Access Compliance Report

Public Rights-of-Way

Intersection ID: 25775	Main Street: CARMEL_RD	Cross Street: PINEVILLE-MATTHEWS_RD	Location: SW
ADA ID: BA48D1C4A99E	Ramp Type: IslandPerp	Initial Pass/Fail: Fail	Overall Compliance: No
Severity Score: 21.25			
Codes/Mitigation Info/Possible Solution		Field Measurements/Component Compliance

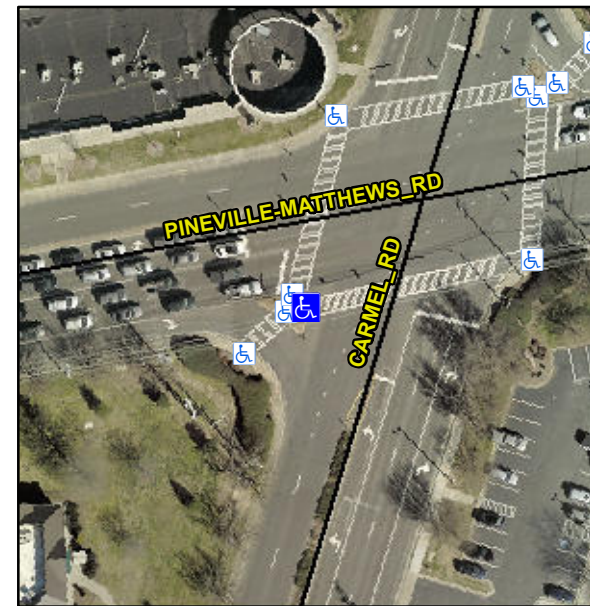
Not Found, R304.5.1, R304.5.3

Compliance	Description	Data	Compliance	Description	Data
N/A	Ramp Length (in)	88.0	Yes	Ramp Slope (%)	6.9
No	Ramp Width (in)	36.0	No	Ramp XSlope (%)	5.4
N/A	Flare Type LT	N/A	N/A	Flare Type RT	N/A
N/A	Flare Slope LT (%)	N/A	N/A	Flare Slope RT (%)	N/A
N/A	Flare Traversable LT?	N/A	N/A	Flare Traversable RT?	N/A
N/A	Landing Length (in)	N/A	N/A	DWS Provided?	N/A
N/A	Landing Width (in)	N/A	N/A	DWS Contrast?	N/A
N/A	Landing Slope (%)	N/A	N/A	DWS Length (in)	N/A
N/A	Landing X Slope (%)	N/A	N/A	DWS Full Width?	N/A
N/A	Landing Curb? (Y/N)	N/A	N/A	DWS Offset (in)	N/A
N/A	Shared Landing?	N/A			
N/A	Gutter Ponding?	N/A	N/A	Gutter Slope (%)	N/A
N/A	Gutter Lip Ht (in)	N/A	N/A	Gutter X Slope (%)	N/A
N/A	Painted X Walk1?	Yes	N/A	Painted X Walk2?	N/A
	X Walk 1 Direction	To E		X Walk 2 Direction	N/A
N/A	X Walk 1 Width (in)	112.5	N/A	X Walk 2 Width (in)	N/A
	X Walk 1 Slope (%)	3.5		X Walk 2 Slope (%)	N/A
	X Walk 1 X Slope (%)	3.1		X Walk 2 X Slope (%)	N/A

Remove & Replace Entire Ramp.
